UNITED STATES PATENT AND TRADEMARK OFFICE

APPLICATION NO.	FILING DATE	FIRST NAMED INVENTOR	ATTORNEY DOCKET NO.	CONFIRMATION NO.
10/697,034	10/31/2003	Rodolphe Lourdel	0529-1021	1105

Office Action Summary	Application No. 10/697,034	Applicant(s) LOURDEL ET AL.	
	Examiner James L. Swiger	Art Unit 3733

DETAILED ACTION

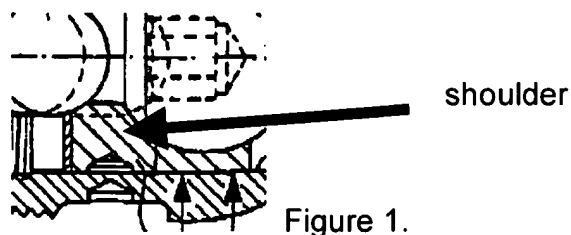
Claims 1-3 and 6 are rejected under 35 U.S.C. 102(b) as being anticipated by Biedermann et al (U.S. Patent No. 5,672,176). Biedermann et al. discloses a device having a connector (5), a connecting rod (15), a screw having a spherical head (1) with a threaded body (2) and an external diameter greater than the spherical head (Fig. 3). Biedermann et al. further discloses a connecting element (16), vertical branches (11 and 12), a U-shaped opening (7), and a locking clip as a blocking device (20) with pressure screw (40). The connecting element has a vertical bore (in the direction of arrow F in Fig. 1). Biedermann et al. also discloses a threaded socket (13). Biedermann et al. also discloses a device where the circular and screw-threaded portions form an internal shoulder. See Fig. 1 below.

The disclosed device also has an internal diameter of the bore smaller than the threaded portion.

Biedermann et al. finally discloses a cylindrical body with threaded screw external surface (46) with an internally opened bore (47) that can form a bearing surface.
